Proposed Residential Subdivision

Milldale, Wainui East

# **FAST TRACK APPLICATION: SPECIALIST COMMENTS RESPONSE ADDENDUM**

Fulton Hogan Land Development Limited

CLIENT: <b>FULTON HOGAN LAND DEVELOPMENT Ltd.</b>	DRAWN: JRAS	PROJECT: AKL2024-0185
PROJECT: <b>MILLDALE TEMPORARY WASTEWATER TREATMENT PLANT</b>	CHECKED: JP	DRAWING: 01
TITLE: <b>GEOTECHNICAL INVESTIGATION PLAN</b>	REVISION: 2	SCALE: 1:800
	DATE: 12/06/2025	SHEET: A3 L

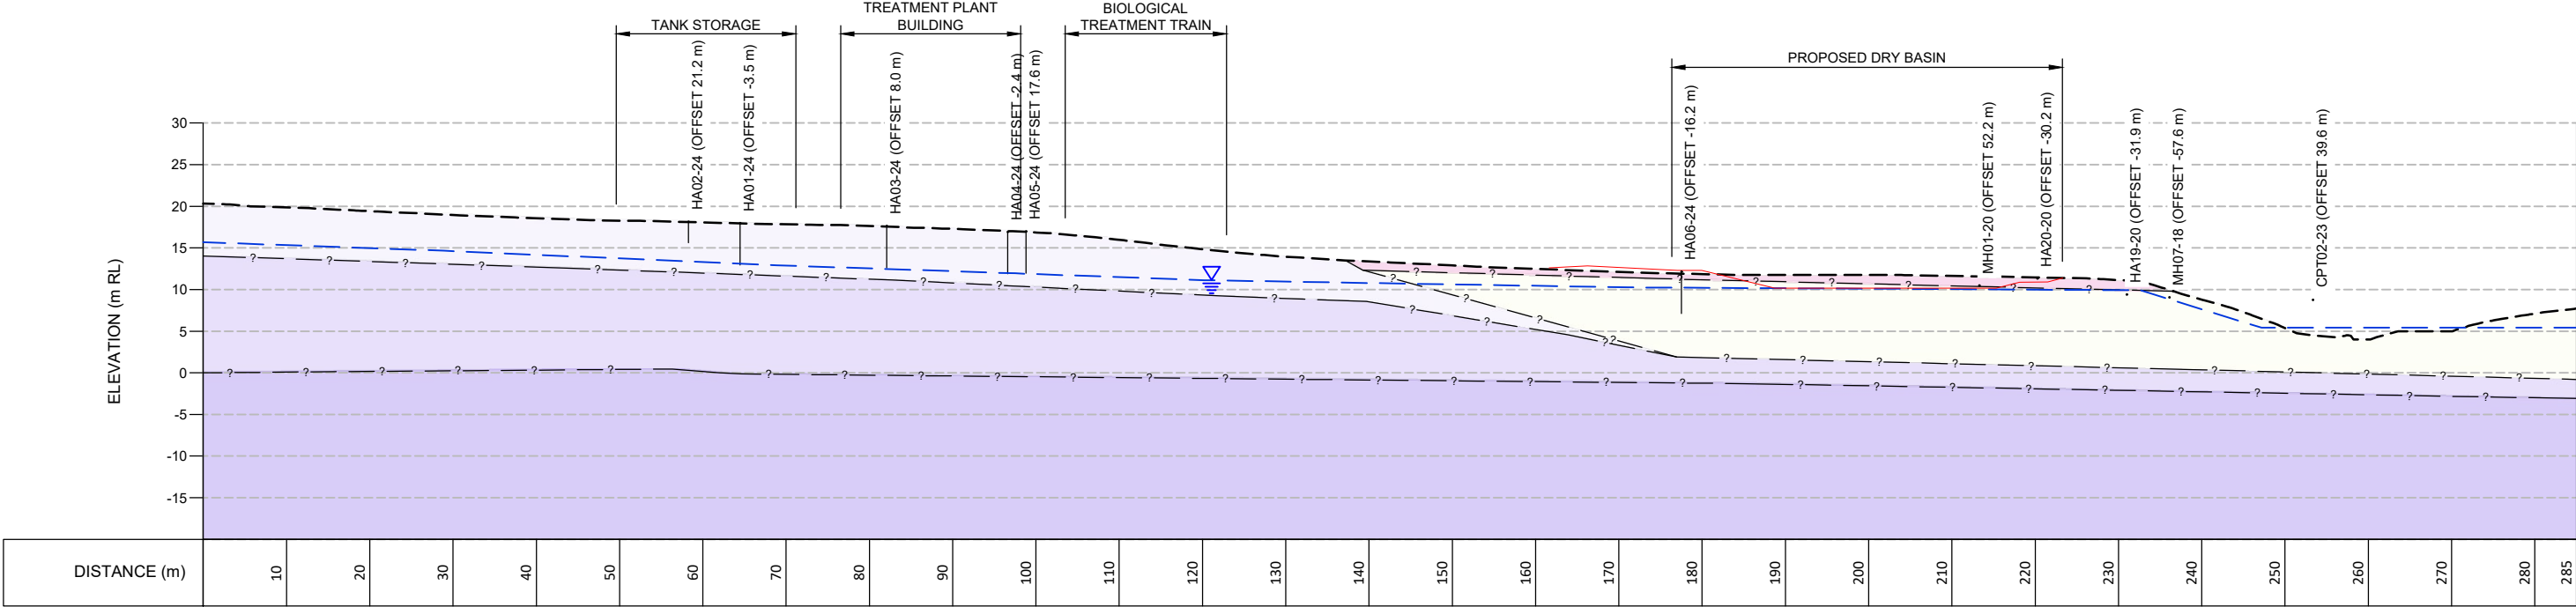
20.25	<p>Site plan only showing locations of hand augers undertaken for this stage of the works, though Section 5.1 has stated previous investigation locations should also be shown on the site plan. It is unsure what deep investigation data was relied on to create the geological cross section as the hand augers are only 5m deep.</p>	<p>The CMW Geotechnical Investigation Plan and Cross Section A (WWTP DG 01 &amp; 02) have been updated to include the mentioned previous investigations and are shown below, and included in <b>Appendix A</b>. The related logs are in <b>Appendix D</b>.</p>

Drawing  
STAB 13

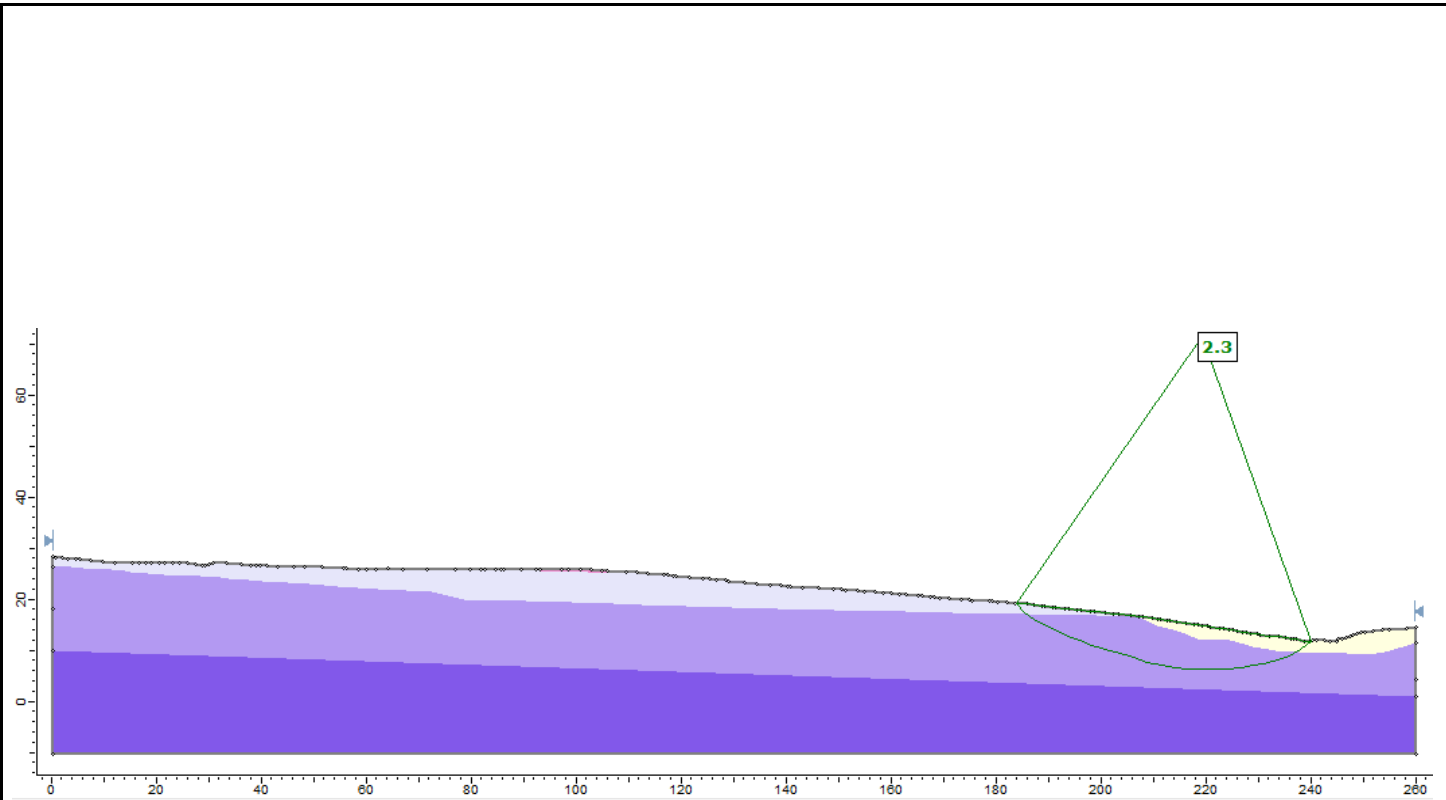
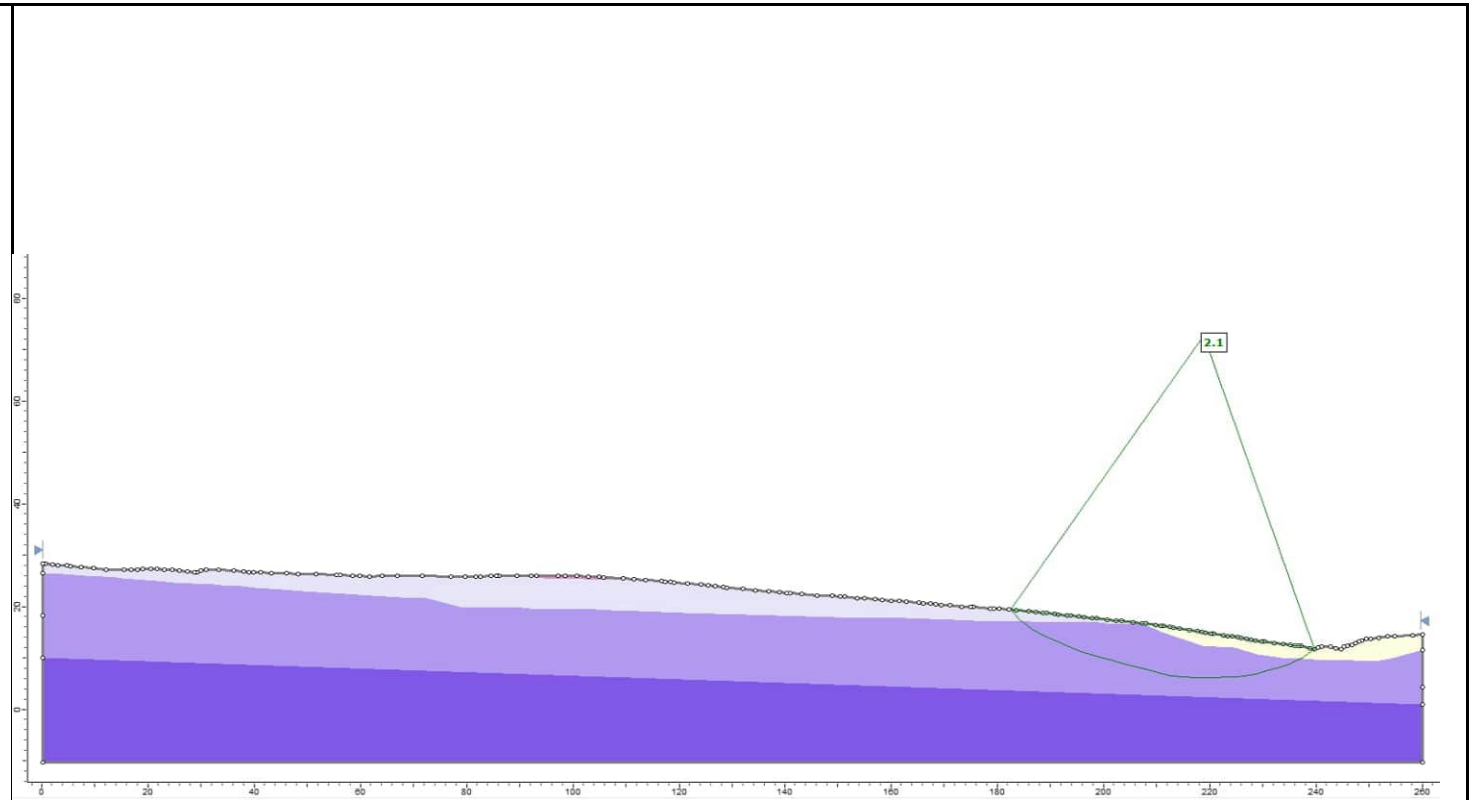
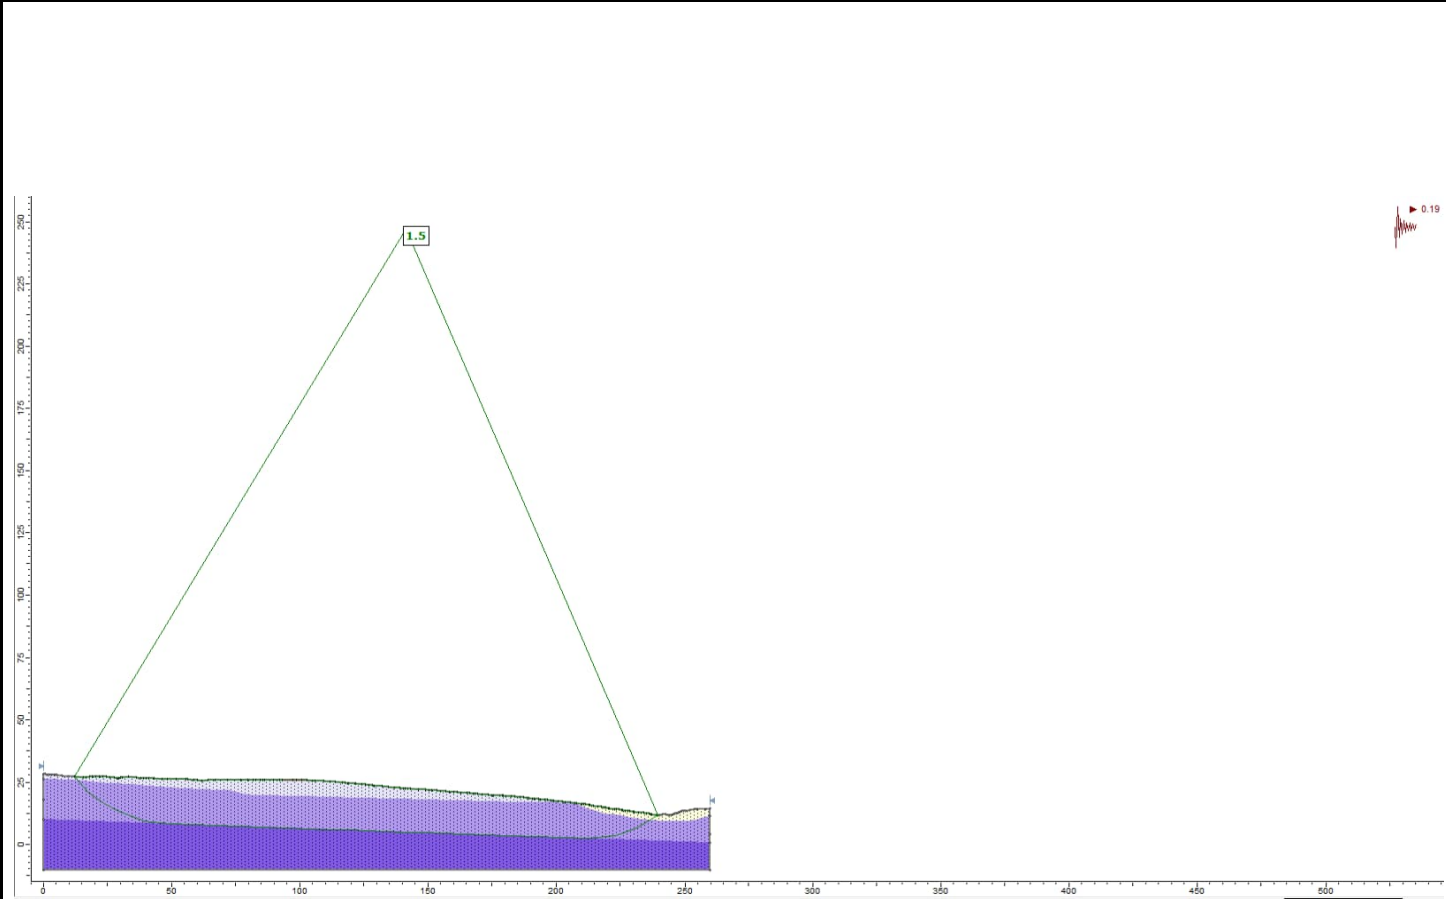
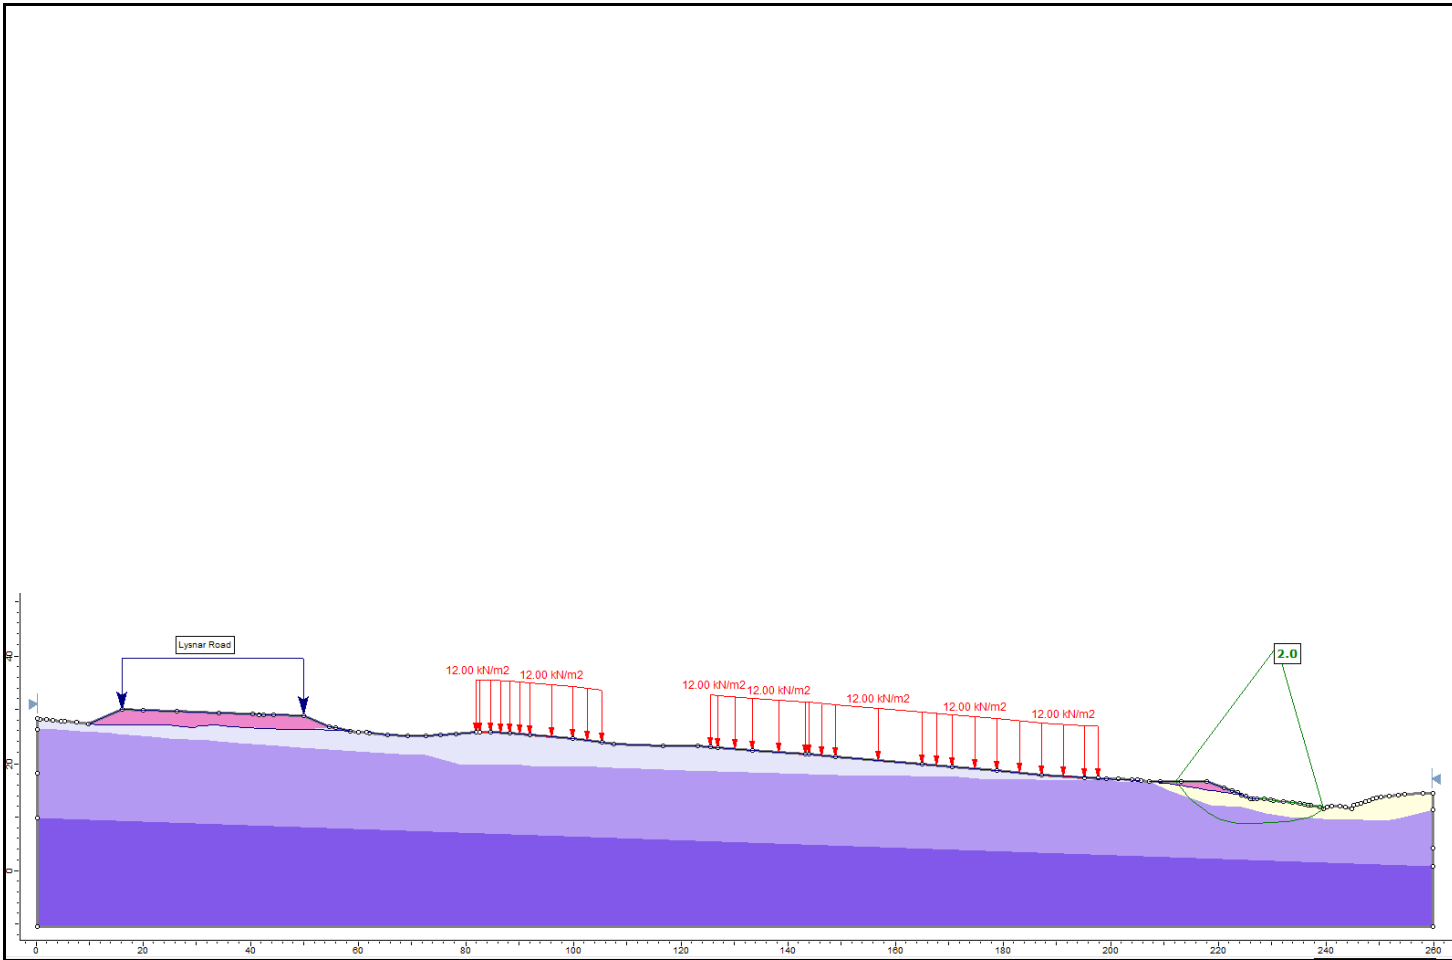
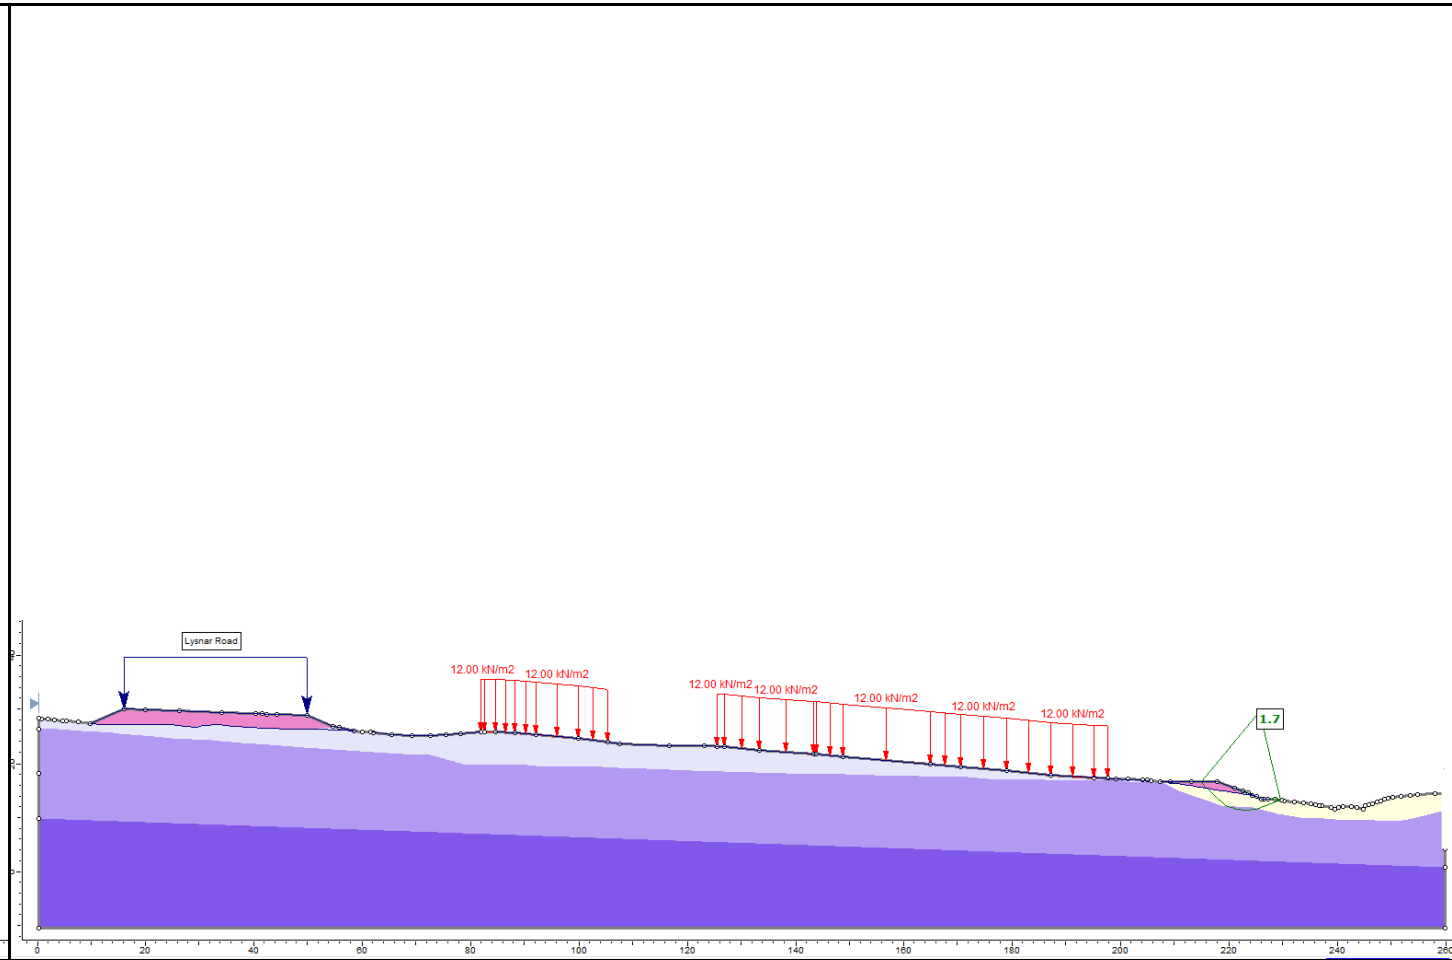
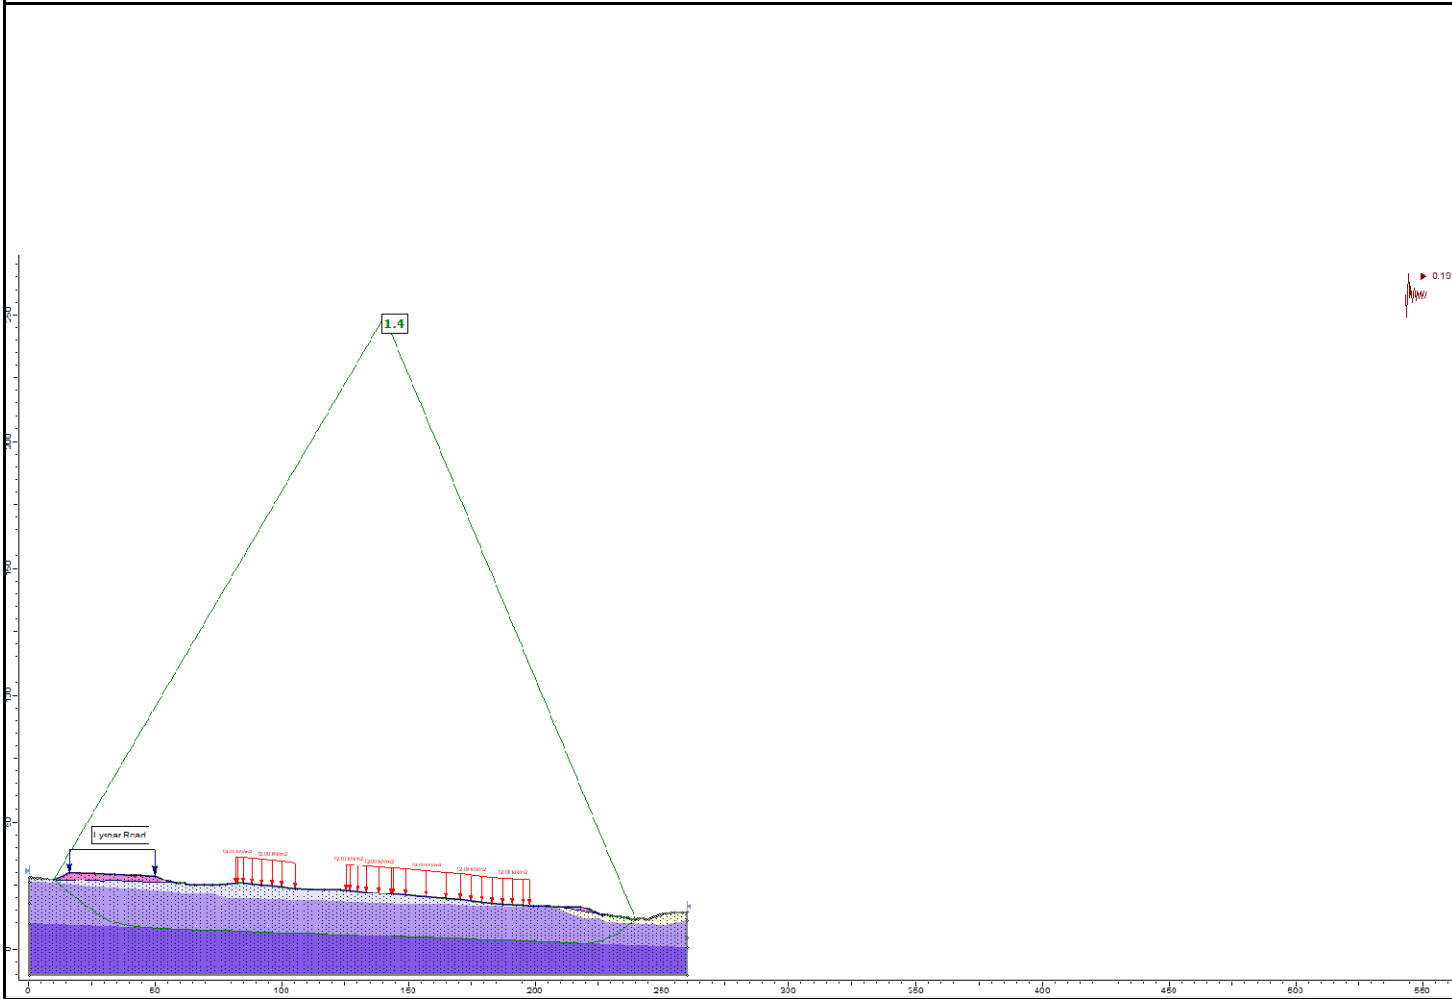
Item #	Auckland Council Comments	Final Comment to Auckland Council in Response to Item
	 <p>Retaining wall plan</p>	
20.5	<ul style="list-style-type: none"> <li>No cross sections or slope stability analyses are provided along the existing overland flow path where the softened alluvium material is expected to be the deepest.</li> <li>Further, the proposed stockpile area located above a gully feature and overland flow path (north of stage 12) may pose a risk of instability and the only reference in the reporting is for the locations to be approved by a geotechnical engineer prior to placement. We suggest that this be provided for review or an annotation provided on the plans to reinforce that its location is subject to geotechnical endorsement.</li> </ul>  <p>SHEET 1202-EW</p> <p>PROPOSED TEMPORARY TOPSOIL STOCKPILE AREA</p>	<ul style="list-style-type: none"> <li>We have provided additional stability cross sections across the stream near the eastern end of the site to demonstrate approximate extents of the palisade action required beneath the culvert headwall shown on the Woods drawings. (XS M &amp; XS N, locations shown below). Stability analyses of these new sections indicates that palisade action is not required at these locations to achieve the required global stability factors of safety. Further site specific investigation and design will be undertaken to inform the design of the proposed culvert headwall (marked in yellow below), including the extents of the required palisade component. Stability outputs for these sections are below and in <b>Appendix C</b>.</li> </ul> <p><b>Cross Section M: - Proposed Slope, Transient Elevated Groundwater Condition:</b></p>  <p><b>Cross Section N: - Proposed Slope, Transient Elevated Groundwater Condition:</b></p>
